SAUSALITO-MARIN CITY SANITARY DISTRICT

**ADDENDUM NO. 2**

**Treatment and Wet Weather Flow Upgrade  
(Project No. 0055-006)**

**January 25, 2017**

DWG NO C100-2  
SHEET NO 41 OF 226  
PROJ NO 055-006  
DATE NOVEMBER 2016

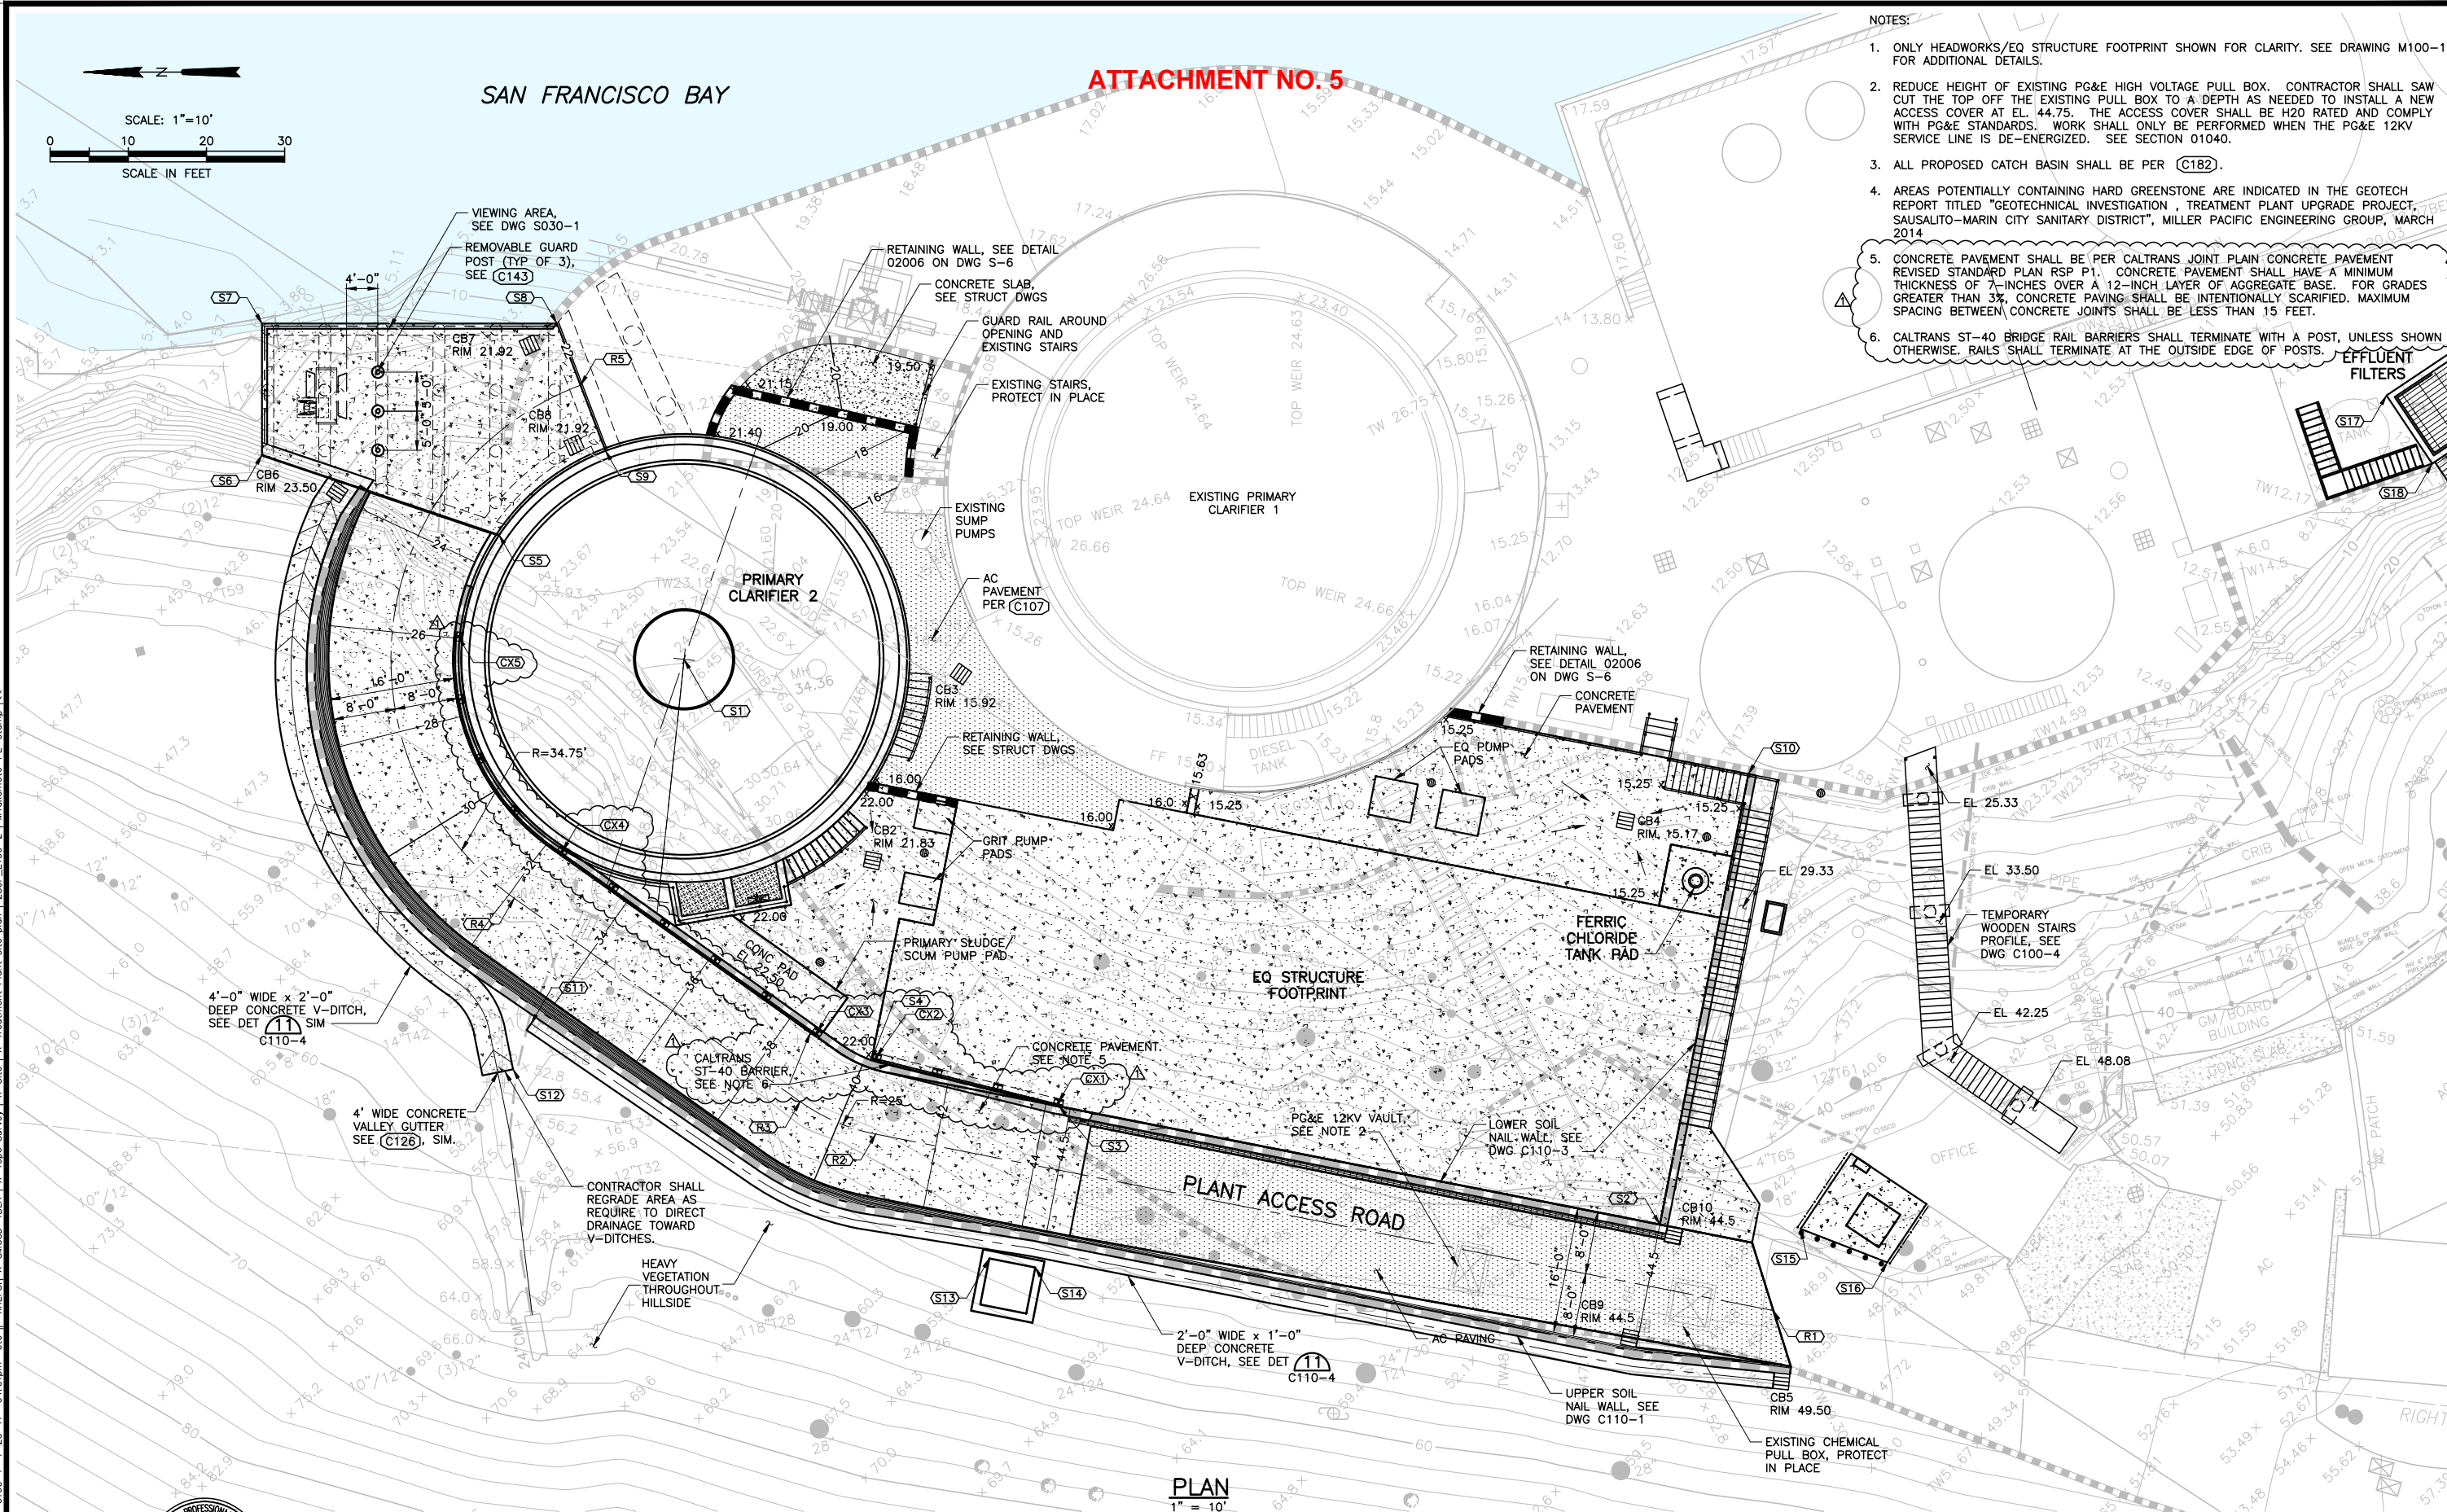
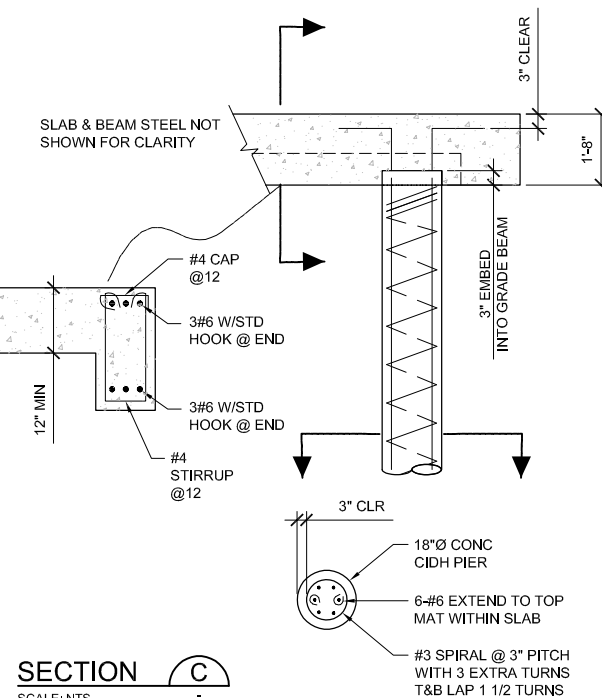
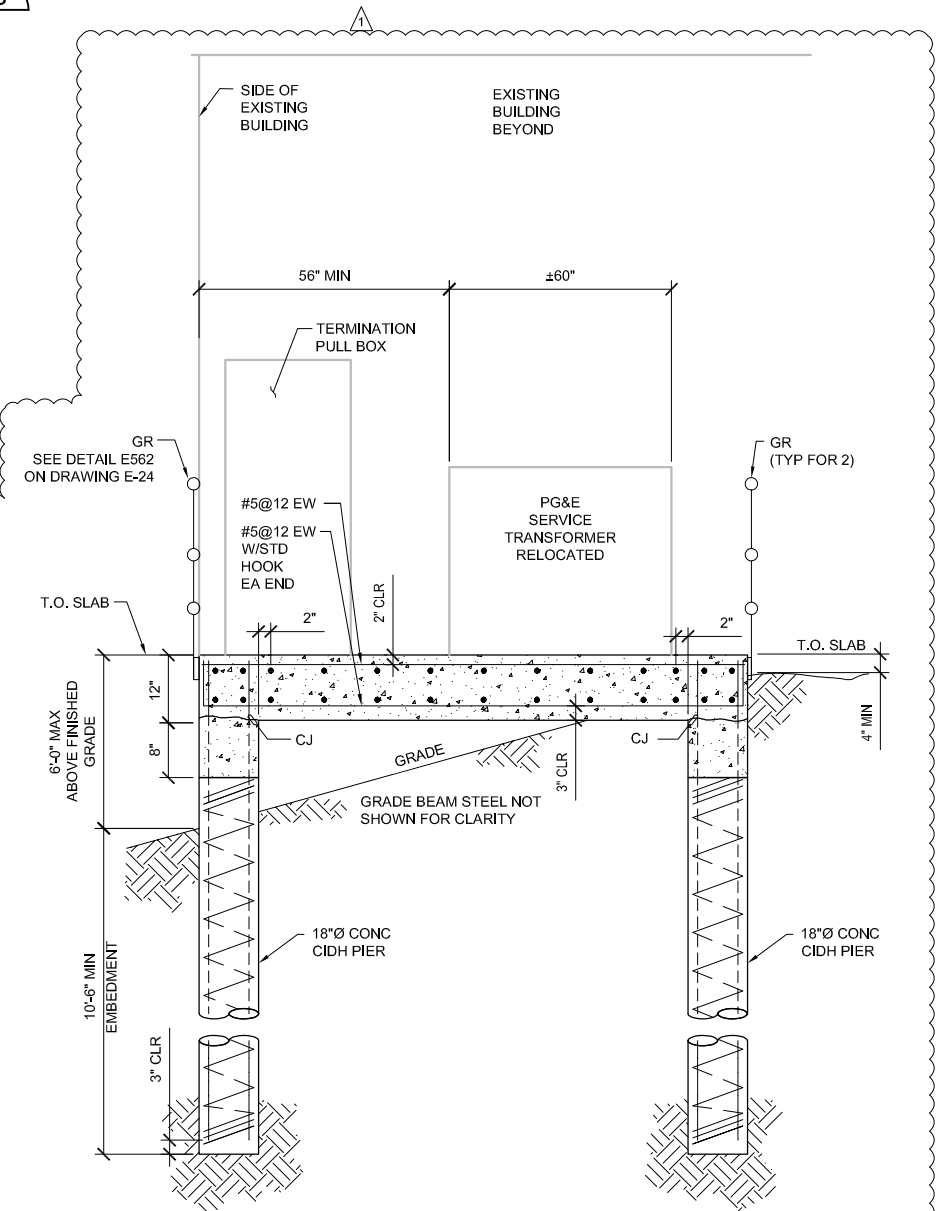
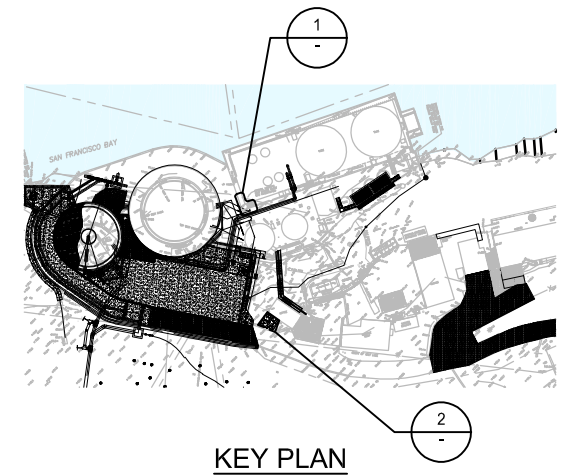
**2.05 Sheet 41, Dwg. No. C100-2 SITE GRADING AND PAVING PLAN – 1**

**Change:** Delete Sheet 41, Dwg. No. C100-2 in its entirety and replace with version as provided in Attachment No. 5.

**2.32 Reference:** Drawing C100-2 and Geotechnical Report (Miller Pacific Engineering Group, July 15, 2013)

**Question:** There is little information provided as to the location of concrete construction joints on either Drawing C100-2 or the Geotechnical Report prepared by the Miller Pacific Engineer group, for the new Plant Access Road. Is there a specific requirement for the location (max spacing) of concrete construction joints (not otherwise depicted) for this project?

**Response:** On Sheet 41. Dwg. No. C100-2, "AC Paving" is called out for the new Plant Access Road adjacent to the new Headworks/EQ structure. Concrete construction joints not applicable to this portion of the Plant Access Road.

DWG NO	S-15
SHEET NO	93 OF 226
PROJ NO	055-006
DATE	NOVEMBER 2016

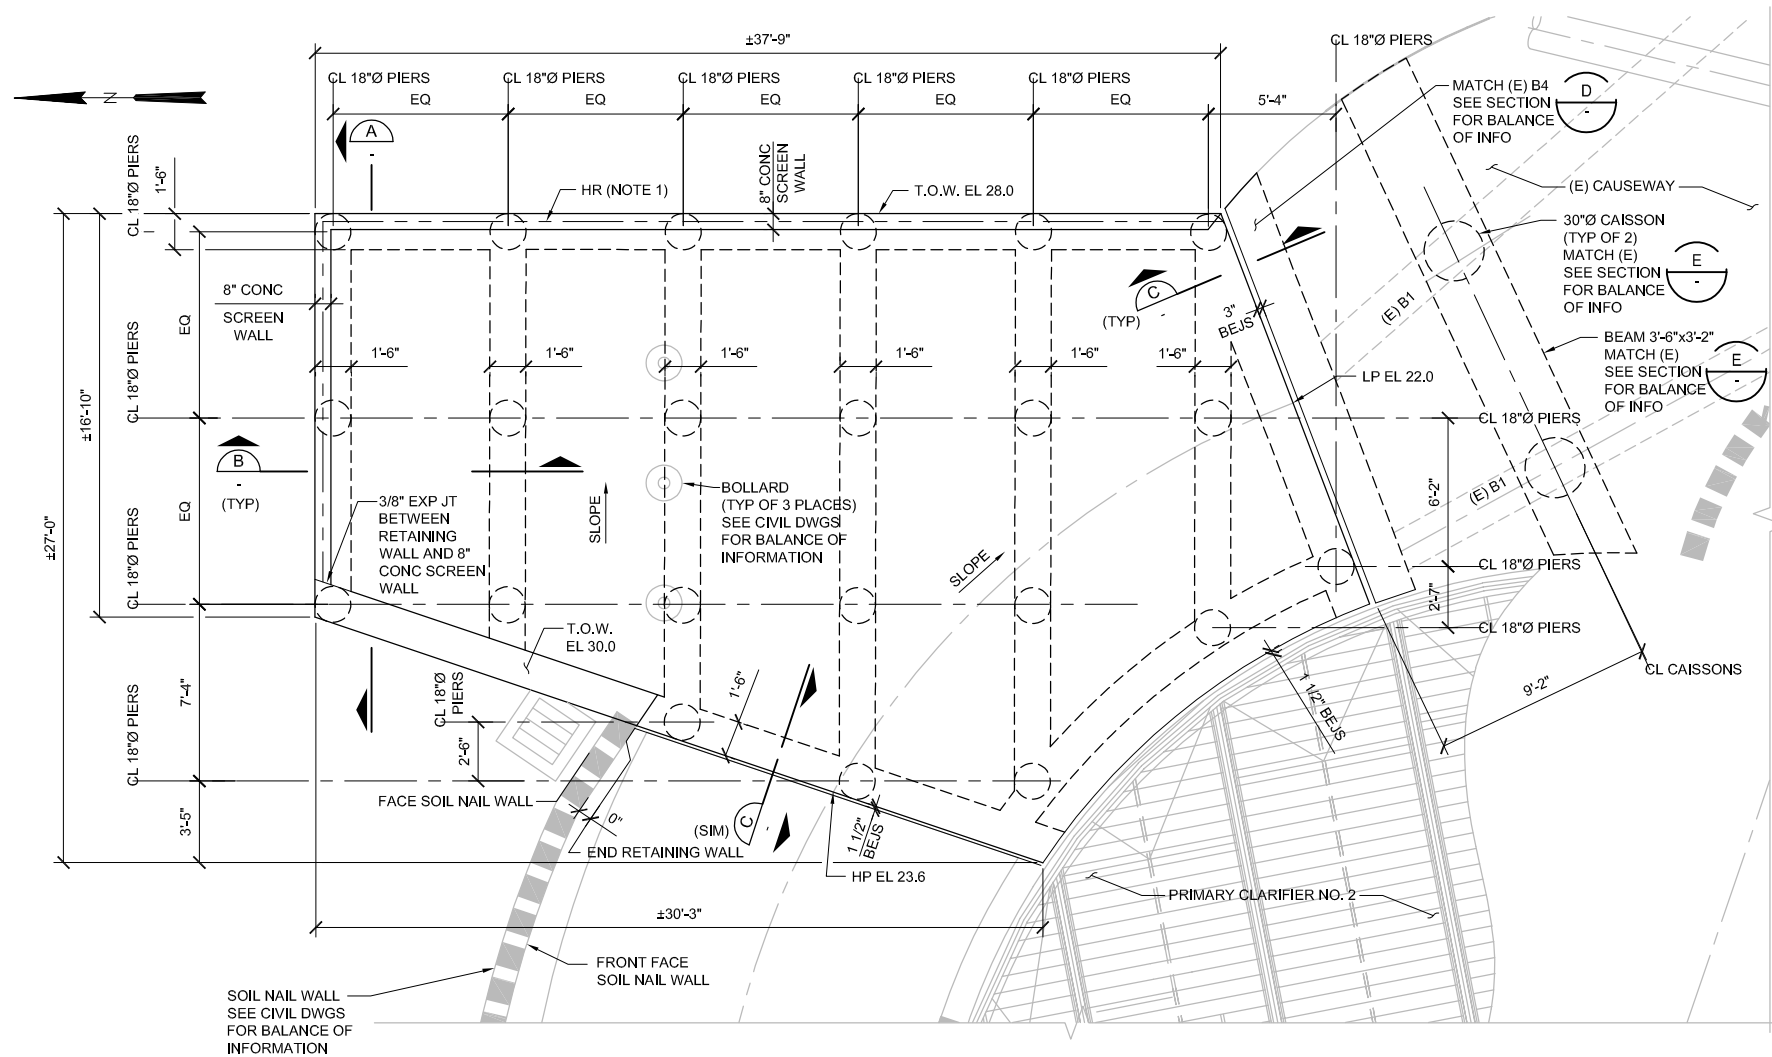
**2.17 Sheet 93, Dwg. No. S-15 STANDARD DETAILS**

**Change:** Delete the sheet in its entirety and replace with version as provided in Attachment 5.

DWG NO	S030-1
SHEET NO	96 OF 226
PROJ NO	055-006
DATE	NOVEMBER 2016

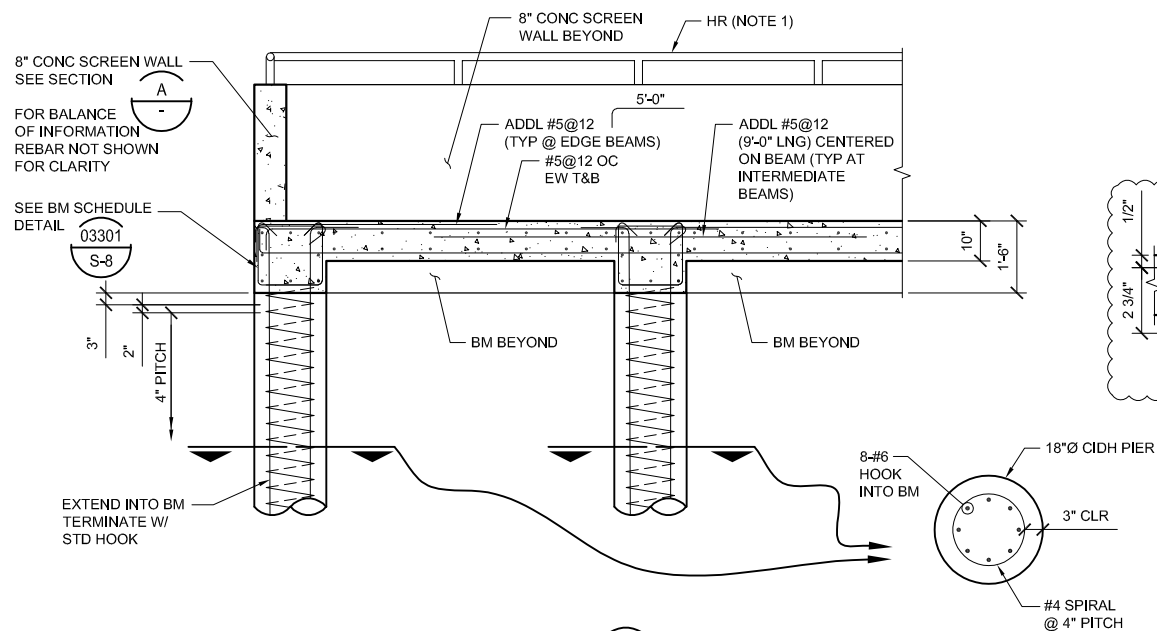
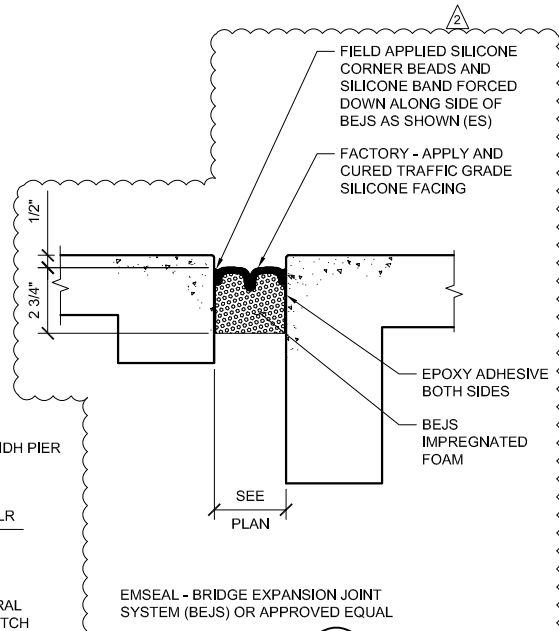
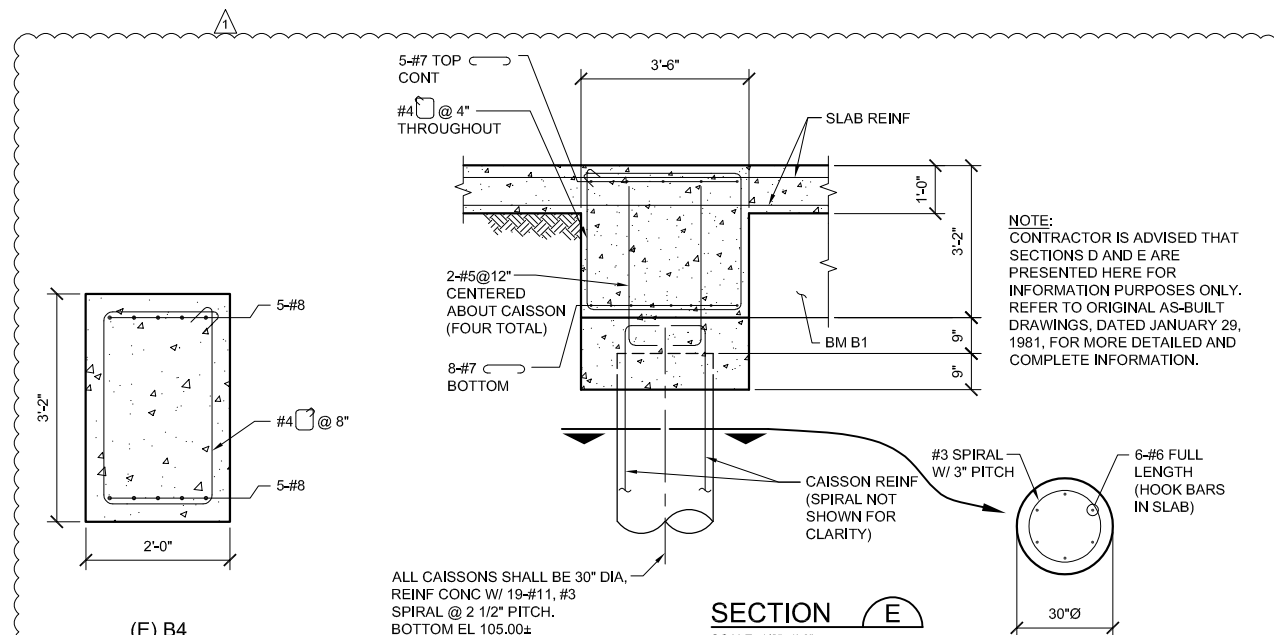
**2.18 Sheet 96, Dwg. No. S030-1 VIEWING AREA**

**Change:** Delete the sheet in its entirety and replace with version as provided in Attachment 5.

**Question:** The original as-builts show a 3’-6” x 3’-2” beam in the North/South direction on 30” caissons. The new plan says to match existing. The demo plans do not refer to any beams or caissons in the viewing area, just to demolish concrete platform and road per boundaries on C100-2, but the caissons and beam appear to be under the viewing area and conflicting with the new CIDH piers and beams. Are the caissons and beams shown on sheet S030-1 south of the demo boundary new construction? If so, please consider moving the demo boundary to the south of the items to allow for construction. Are the caissons and beams existing as shown on S030-1? If so, does a portion of Beams 1 need to be demolished? What does (E) B4 represent? Is (E) B4 new construction or just an example of the size of the existing beams? What does the phantom line in Section C on S030-1 represent? Is this a new thickened slab edge or existing? Please provide more detailed information for the work in this area.

The “Match (E) B4” beam section is represented in Section D on S030-1. Additional information on the beams called out to match existing can be found in the Beam Schedule on Sheet S-24 from the 1981 Record Drawings.
